Tasman District Council

BC190480

Site Address: 31 Pineview Way, Motueka Valley

Project Description: Construct new dwelling and detached sleepout

SITE PLAN

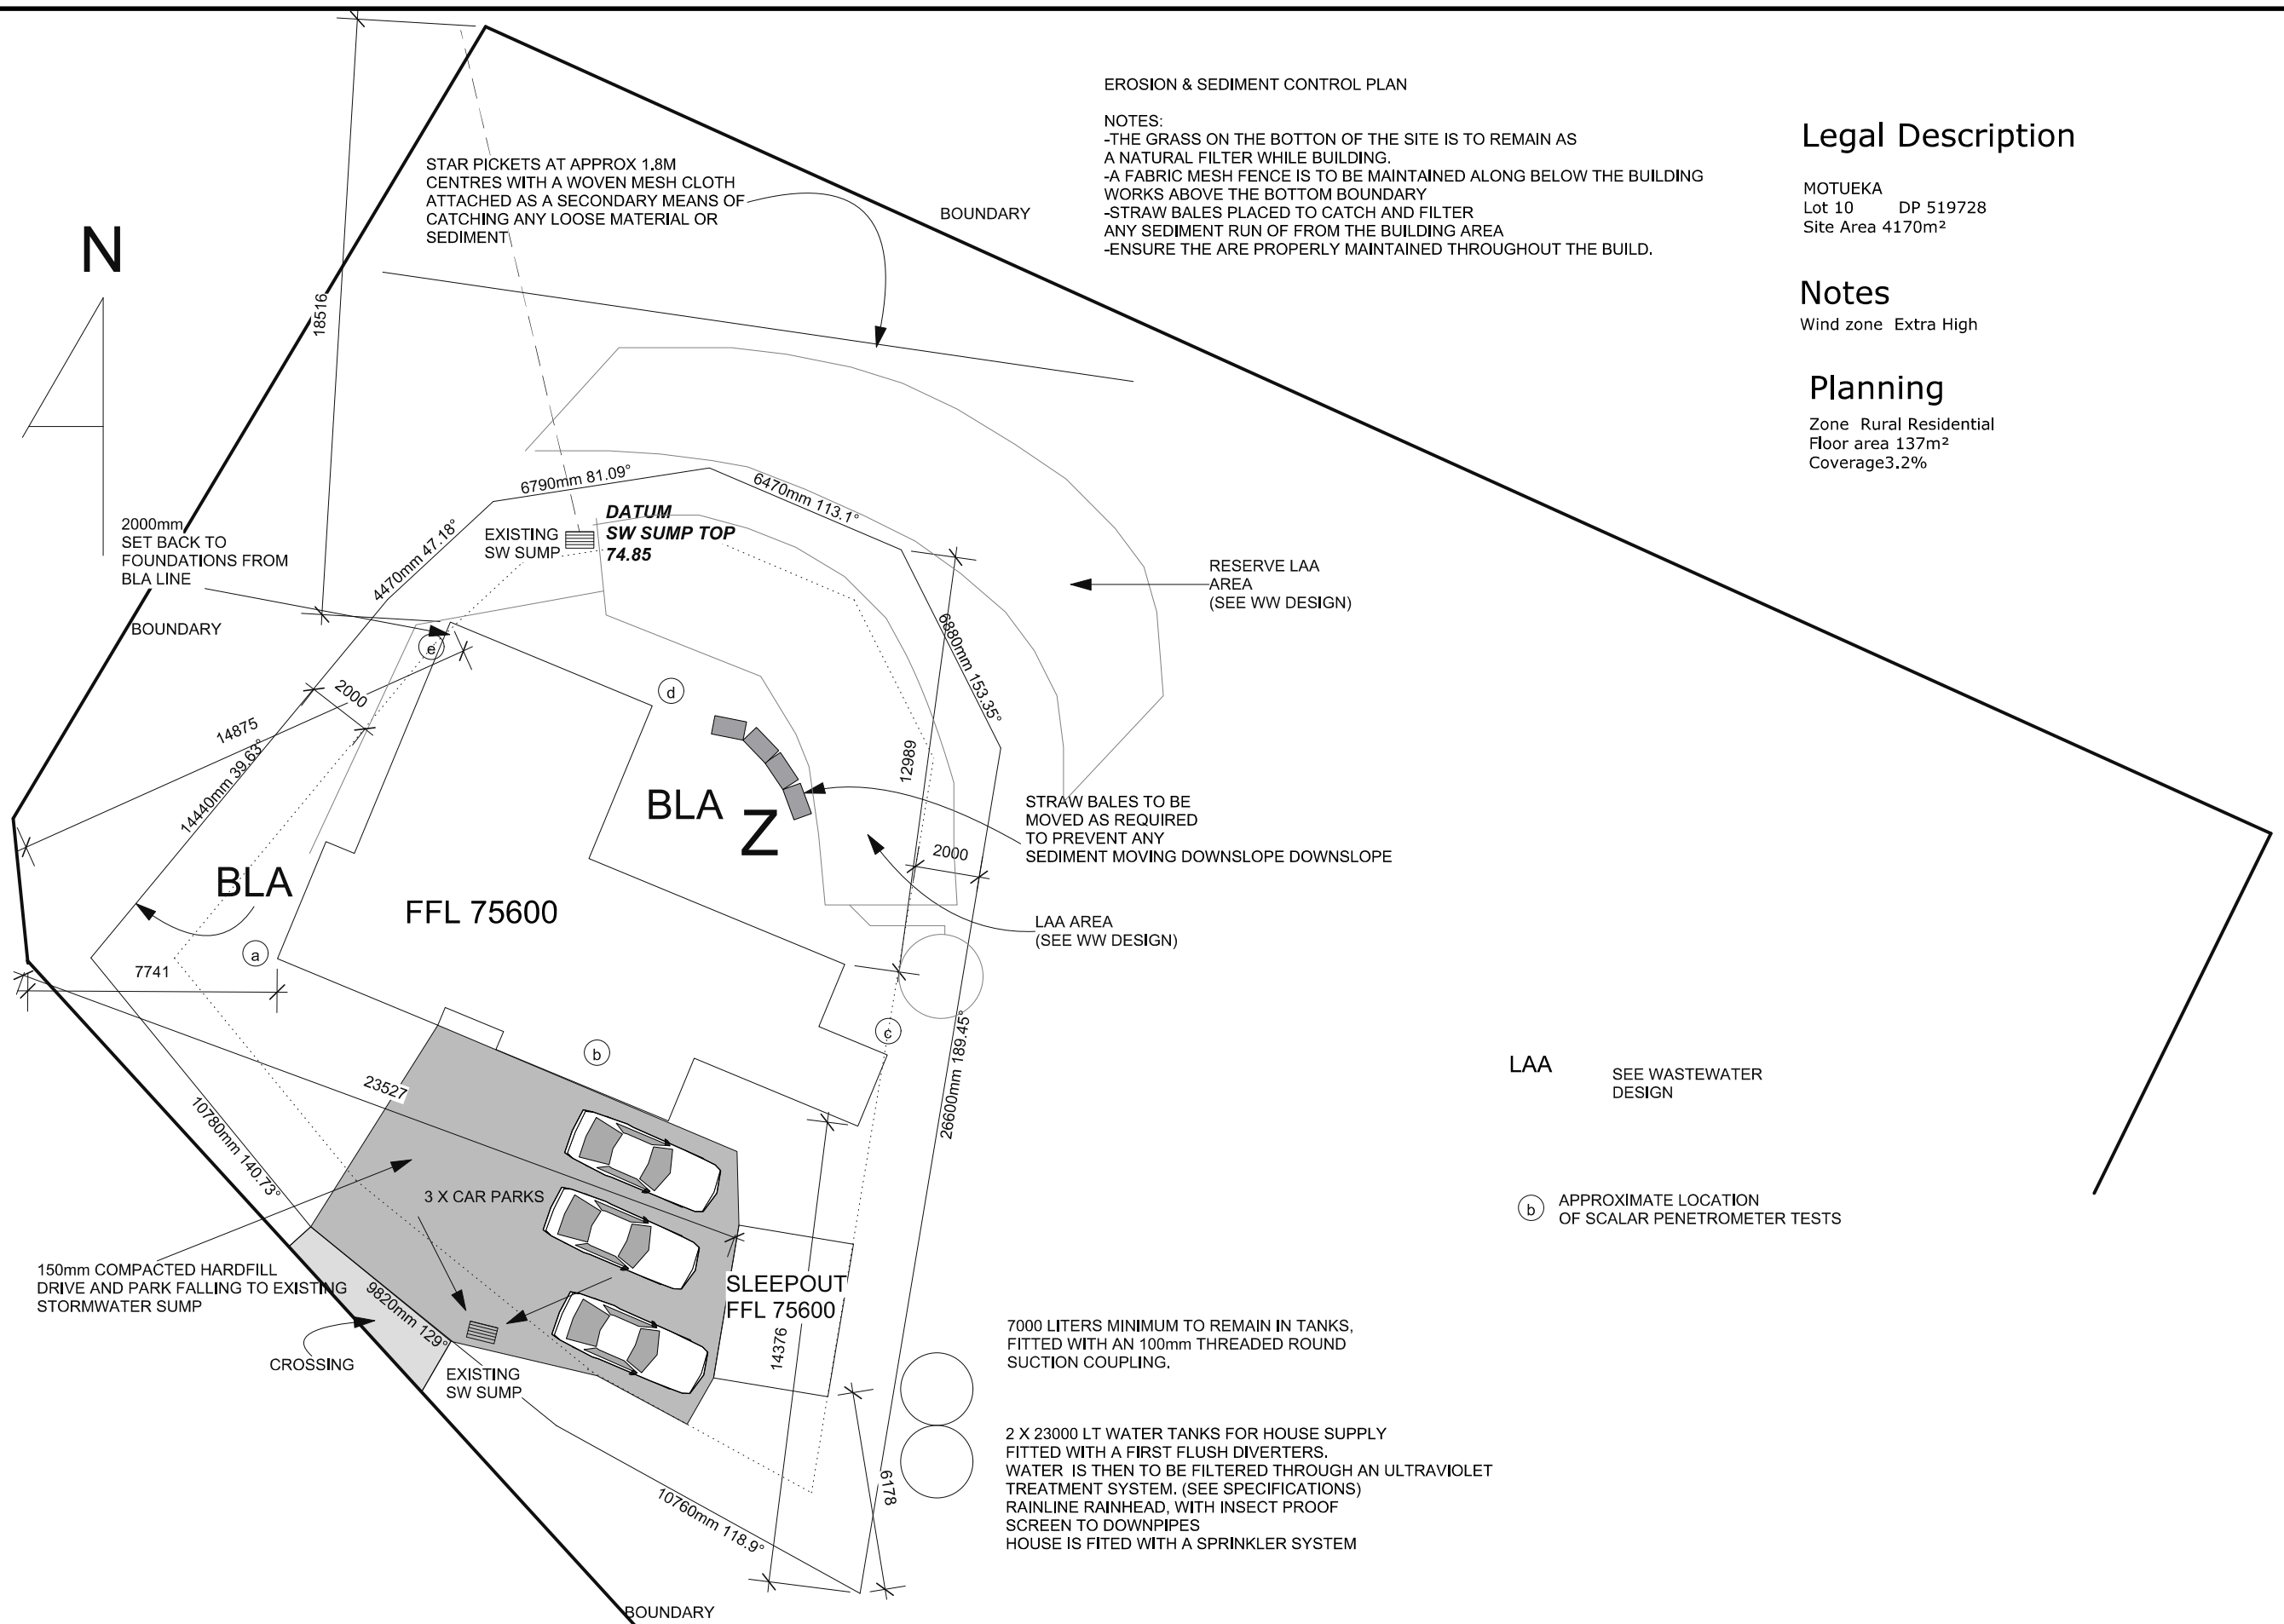
Within the Geo report from Geo-Logic Limited it is indicated on sheet 2 that "there should be a minimum of 5 meters between the west side of the water tanks and any building". Working off the site plan it indicates that the proposed sleep out is to the west side of the water tanks and using scale it would appear to be within 5m, please revise

N	BGn	31/05/2019 01:29 pm	Within the Geo report from Geo-Logic Limited it is indicated on sheet 2 that "there should be a minimum of 5 meters between the west side of the water tanks and any building". Working off the site plan it indicates that the proposed sleep out is to the west side of the water tanks and using scale it would appear to be within 5m, please revise
	RFI	BGn	05/06/2019 04:29 pm	Within the Geo report from Geo-Logic Limited it is indicated on sheet 2 that "there should be a minimum of 5 meters between the west side of the water tanks and any building". Working off the site plan it indicates that the proposed sleep out is to the west side of the water tanks and using scale it would appear to be within 5m, please revise
	Y	BGn	11/06/2019 01:33 pm	RFI Response: Within the RFI response the designer has indicated that a site measure has been preformed on site and the plans have now been revised to indicate the proposed separation of over 7m - SORGed compliance now established

JOIST PLAN
1:100

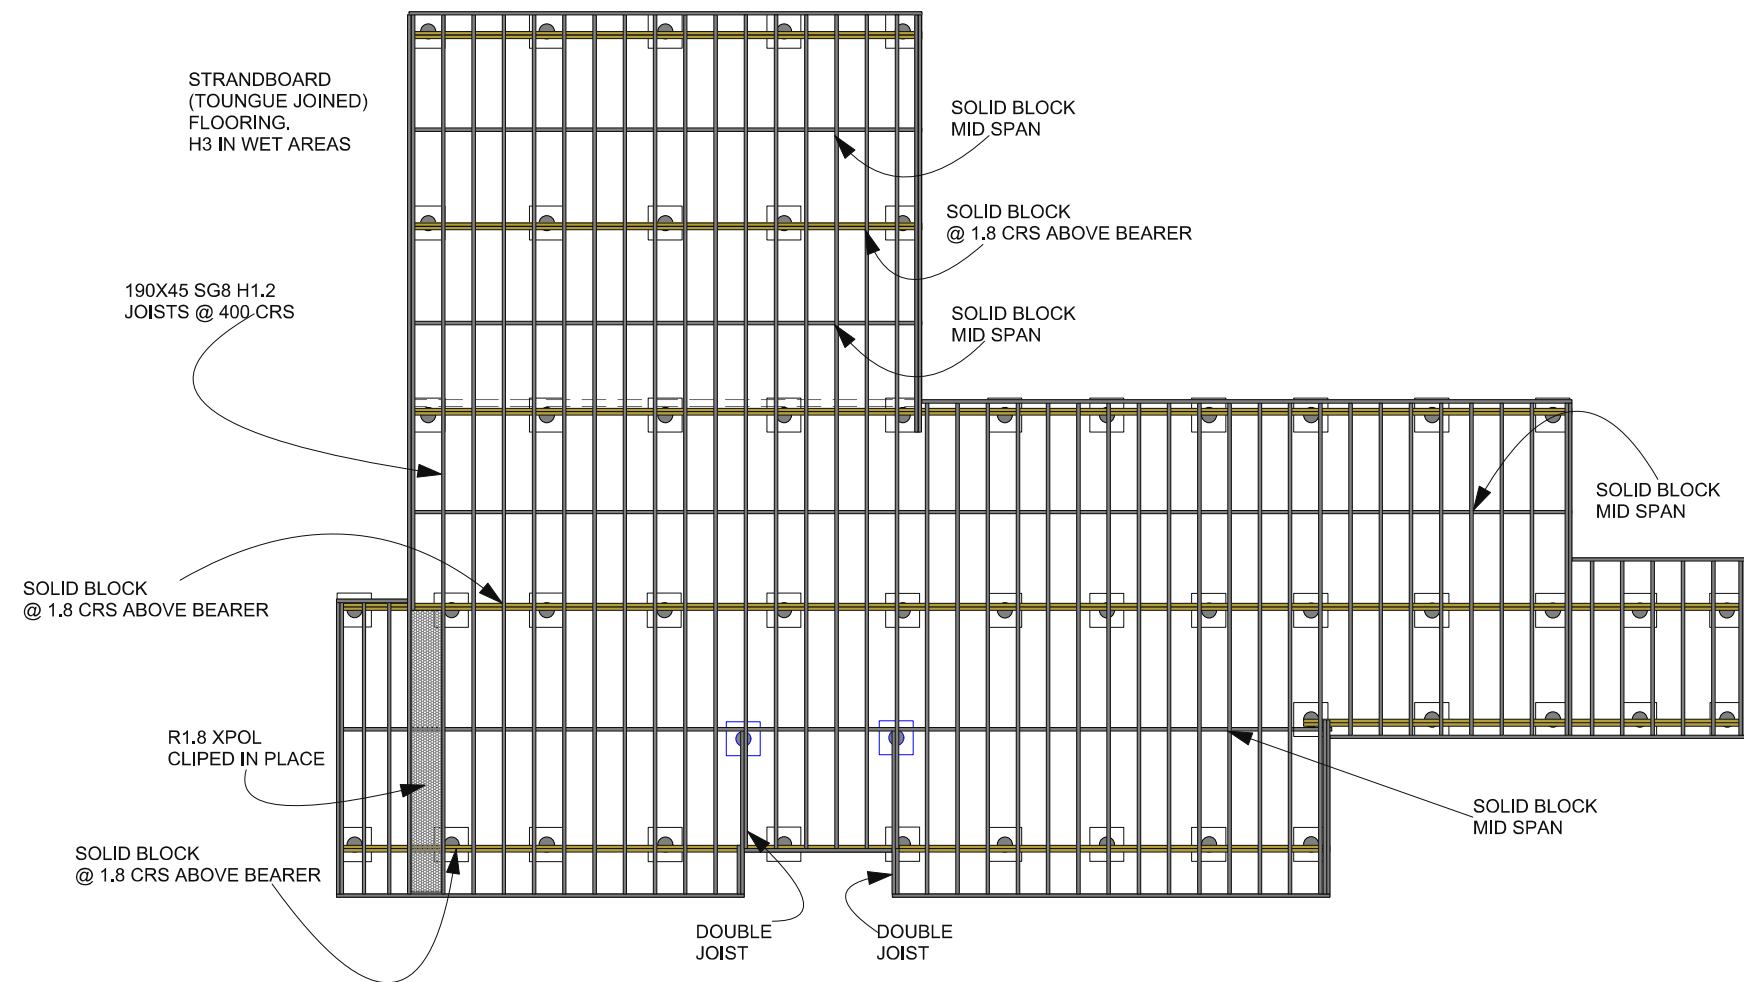
4. Point Loads: Are point loads / load bearing walls correctly supported?	Y	REe	30/05/2019 02:07 pm	Point loads are correctly supported and distributed on load paths. Uniform point loads from roof to external walls / load bearing wall support provided. Double joists under loadbearing walls. Sheet 5 and Roof and Truss Design.

RAFTER PLAN
1:100

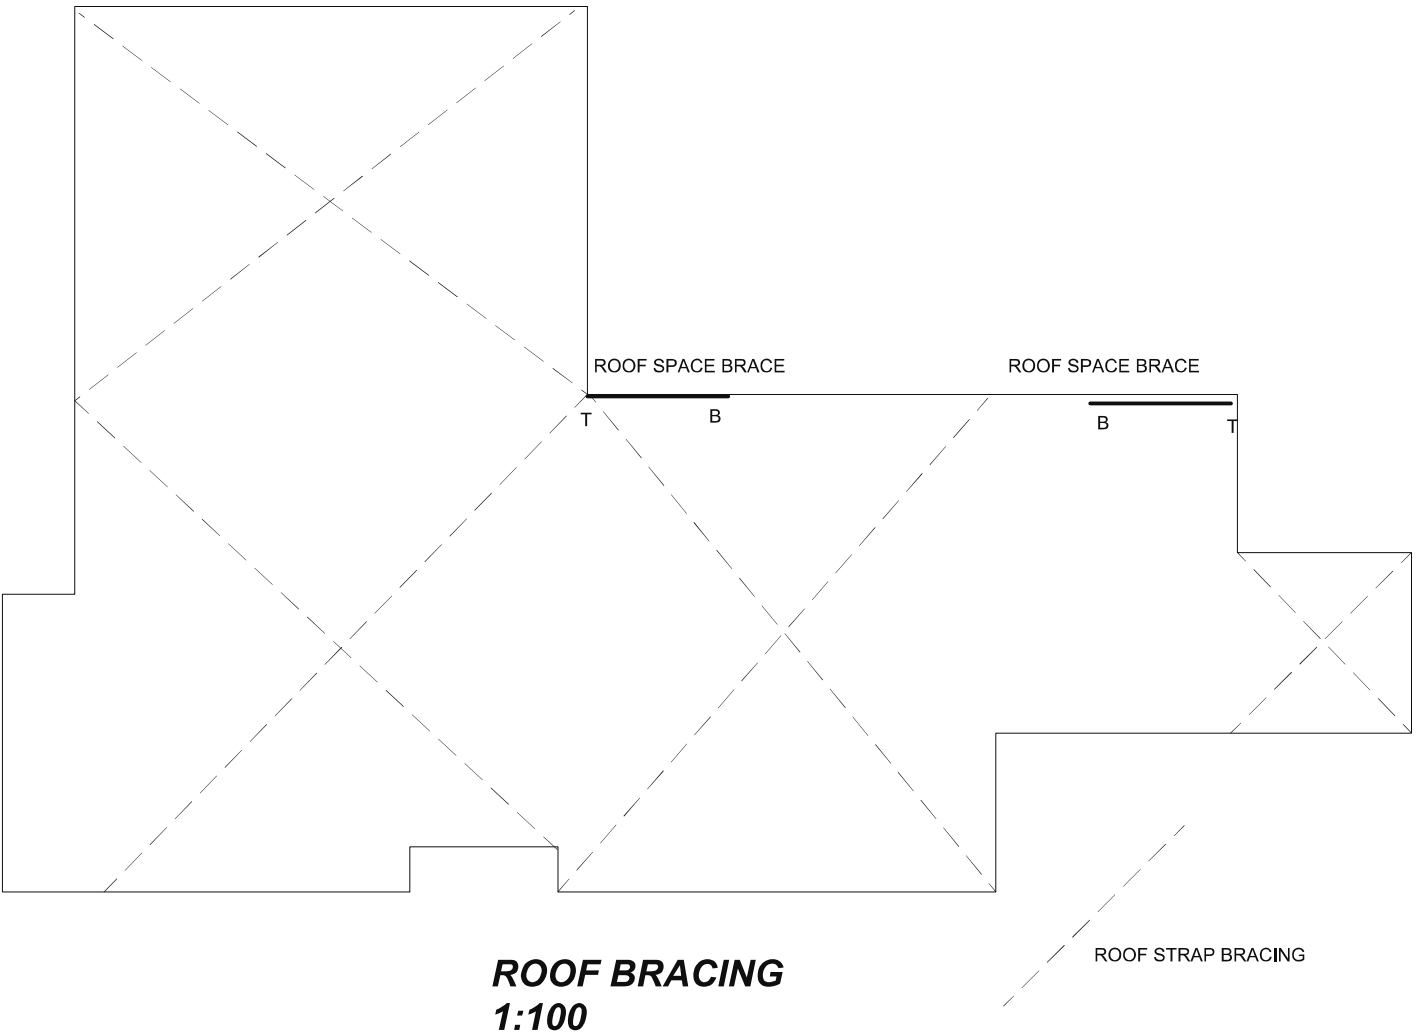
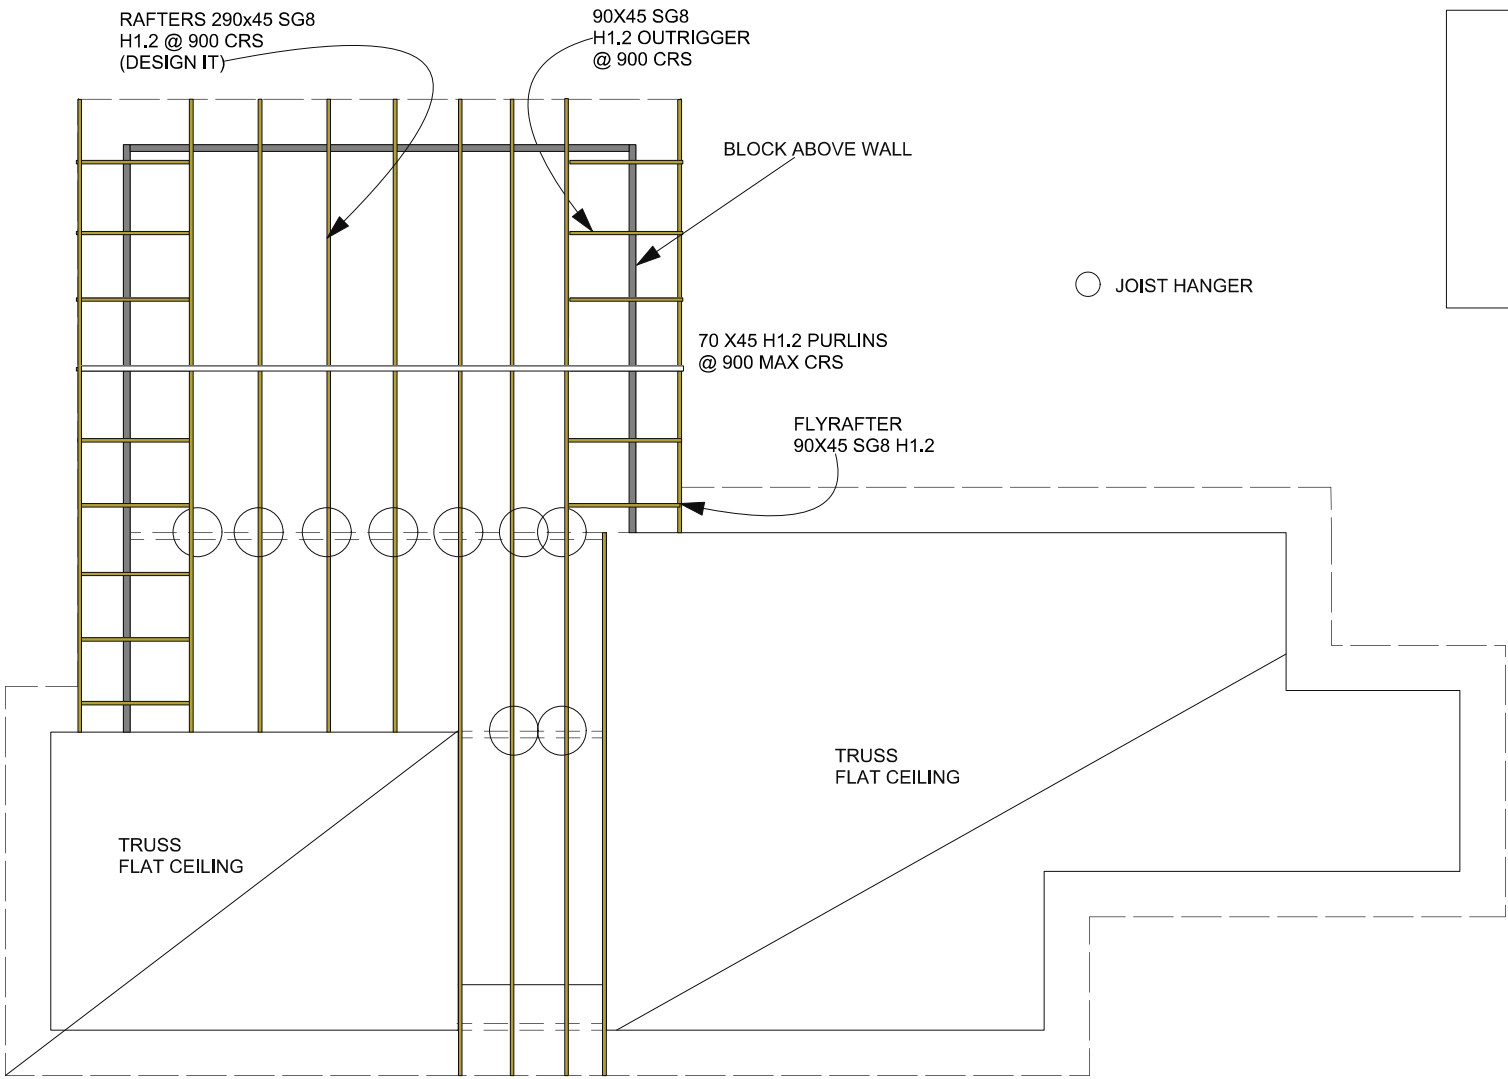
240x45 H1.2 SG8 rafters at 900mm centers proposed spanning roughly 3.6m - compliance measured to table 10.1 of NZS3604:2011 and not achieved, please revise the design so compliance can be established

2. Roof members: Is the detailing of rafters, hips, valleys, ties, joists, ceiling runners, ridge, under purlins, struts and strutting beams compliant?		Y	BGn	04/06/2019 02:47 pm	290x45 SG8 rafters at 900mm centers indicated within the roofing plan [sheet 9] CCH DesignIT Certificate provided indicating 5.1m span applicable [no span proposed greater than this. 90x45 outriggers proposed with 600mm soffit and 90x45 fly rafter [H1.2 SG8]
